ATTACHMENT 13
SECTION M
EVALUATION FACTORS FOR AWARD
FOR
THREE-DIMENSIONAL EXPEDITIONARY LONG-RANGE RADAR (3DELRR)

Revision **F**

26 July 2016

Figure 1 - Visual Summarization of the Source Selection Process Described Above.

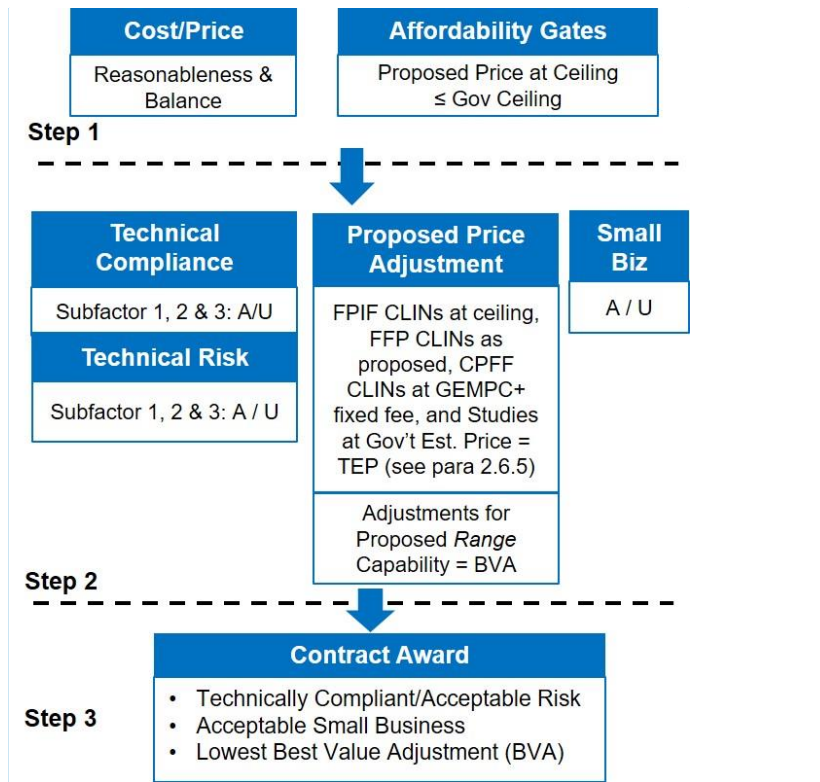
Commented [LAGGUA3]: Need to update to include FFP NTE and CR CLINs into TEP
